**THE CLOUD HOUSE AT  
20 & 20A VICARS ROAD NW5 4NL:

PROPOSAL FOR MINOR  
AMENDMENTS TO THE SCHEME  
SINCE PLANNING PERMISSION  
WAS GRANTED ON 13<sup>TH</sup> JULY 2022**

**Emily Kennedy & Peter Morris – and on behalf of Khin Thuzar Kyi  
OCTOBER 2022**

Illustration 1: Showing the pink metal balustrading which will enclose the Skydoor leading to 20A's terrace  
October 2022

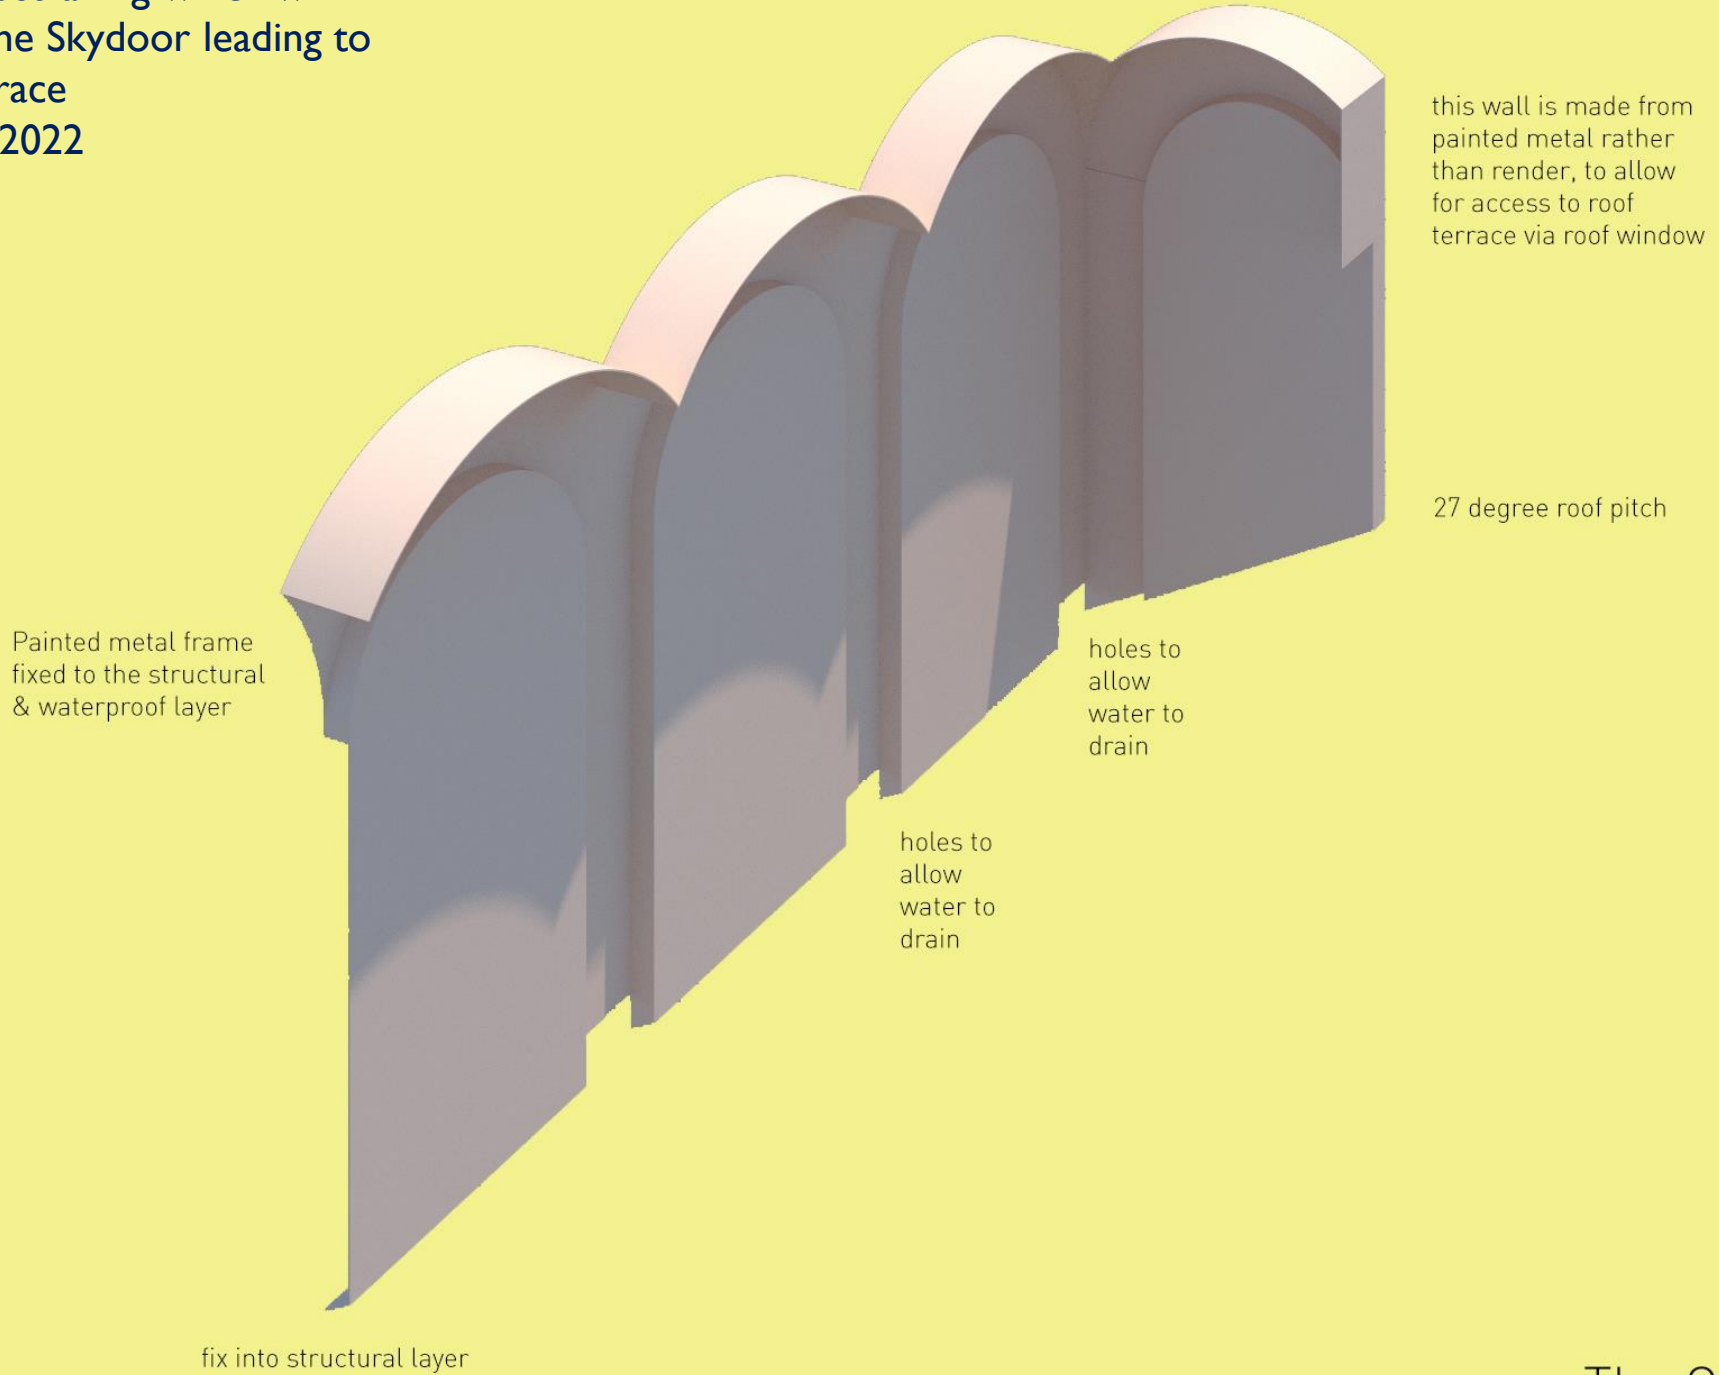
**5) THE REPLACEMENT OF A SMALL PART OF THE RENDERED BALUSTRADE WALL ON THE EAST SIDE OF 20A'S ROOF TERRACE WITH A SECTION OF PALE PINK ARCHED METAL BALUSTRADING, ENCLOSING THE SKYDOOR ON BOTH THE SOUTH AND EAST SIDES, AND TOPPED WITH A 300MM-WIDE METAL CAP TO MATCH THE RENDERED WALL BESIDE IT (please see illustrations 1 & 2)**

REASON: The original plan for a boxlight leading to the roof terrace, with an arched rendered wall sitting in a cloud shape beside it, is not now possible due to space and manufacturing limitations. So the new plan – along with replacing the boxlight with a hinged Skydoor – is to replace the section of rendered wall next to the rooflight with very slim arched metal balustrading that encloses the Skydoor on both its South and East sides. It will be painted pale pink to match the rendered walls, and will be topped with a 300mm-wide metal cap so that it appears to be the same thickness as the rendered balustrade walls beside it. Space is needed for the hinged Skydoor to open behind this new section of metal balustrading – so the arches here won't any longer diminish in height – but they'll be the same height as the built balustrades elsewhere, which will look very elegant.

IMPACT: As the pale pink metal balustrade will look almost exactly the same as the pale pink rendered balustrade, this change will have no visual impact on the view of the building from the street or from neighbouring buildings.

Illustration 2: Showing the pink metal balustrading which will enclose the Skydoor leading to 20A's terrace  
October 2022

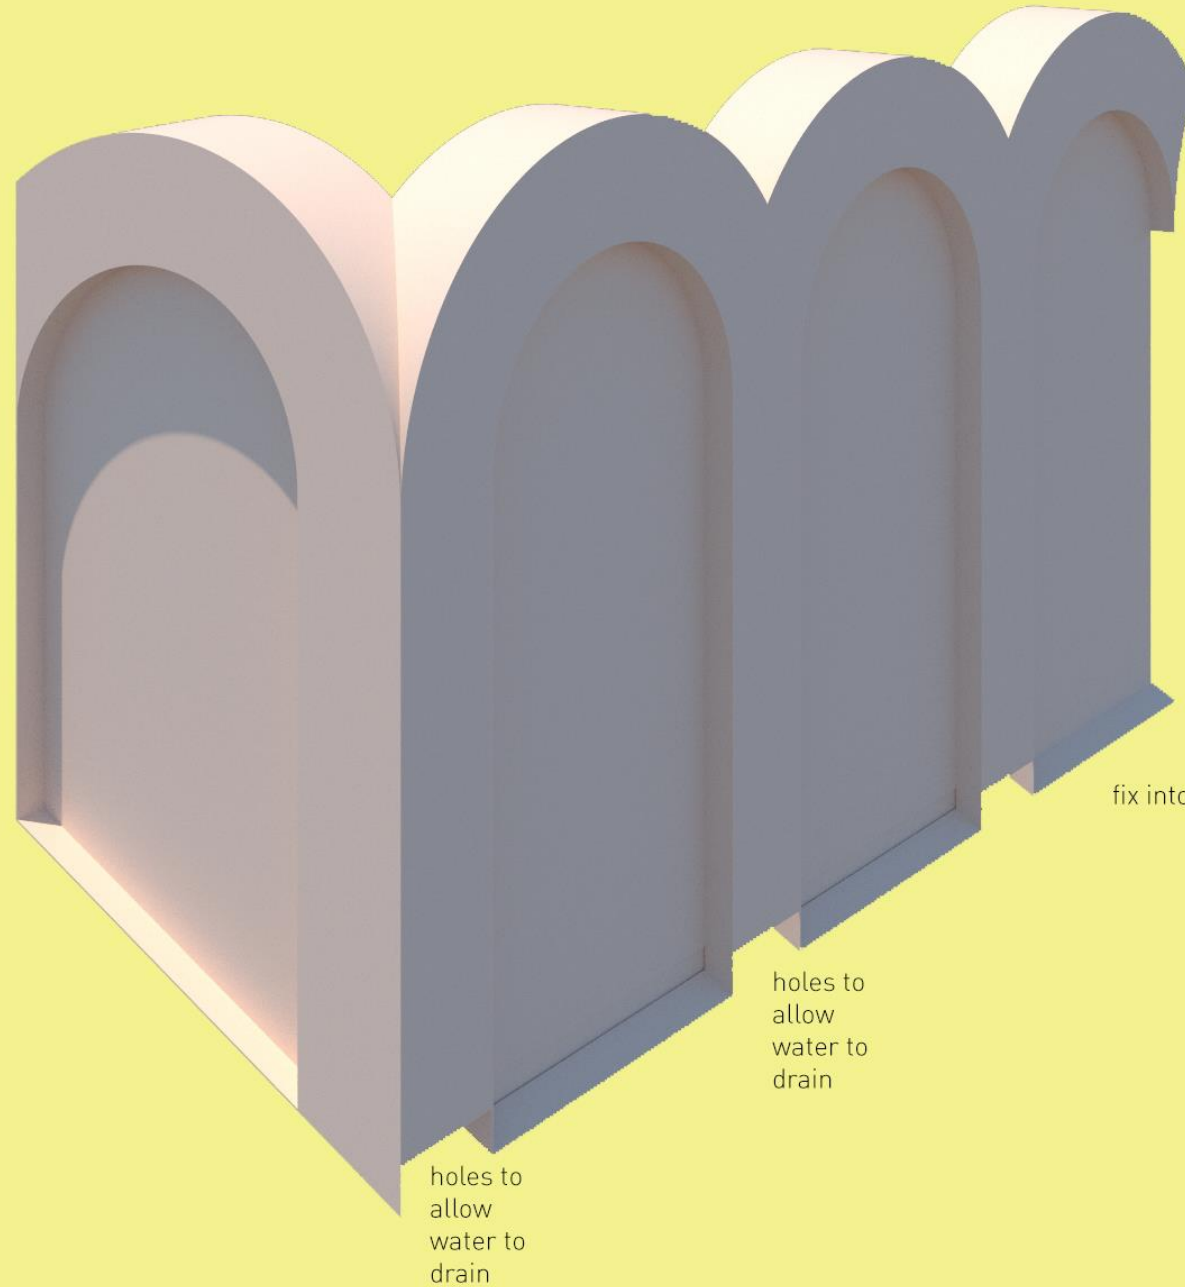
this wall is made from painted metal rather than render, to allow for access to roof terrace via roof window
